Nummer: INFO 2026-02 AAD Vigil Cutter Lebenszeit

Bezug: PIB-01-2026 Vigil Cutter Service Life

Bulletin Number : PIB-01-2026

Subject : Vigil Cutter Service Life

Vigil Cutter DOM MM/YY

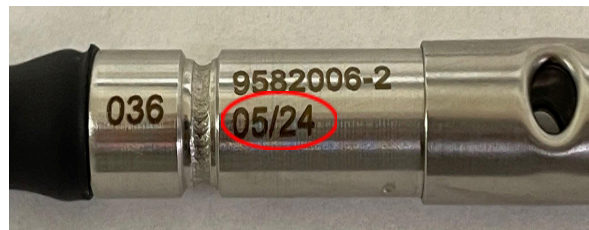
Multiple Vigil units have been returned to our Service Department, and during inspection, the units were found with a replacement cutter that had a DOM older than 6 months prior to the DOM of the Vigil unit. Use of a cutter that is older than 6 months prior to the DOM of the Vigil unit could possibly result in the cutter exceeding its Service Life

Vigil cutters placed on any Vigil unit should not be older than 6 months prior to the DOM of the Vigil unit.

New or used Vigil AADs with a cutter DOM older than 6 months prior to the DOM of the Vigil unit should not be installed in any parachute rig.

If the age of the cutter exceeds 6 months prior to the DOM of the Vigil unit, the complete Vigil unit should be sent back to the factory for servicing and cutter replacement. For Vigil 2+ AADs, the cutter can be replaced in the field.

The expected Service Life of a Vigil cutter is 20 years + 6 months.
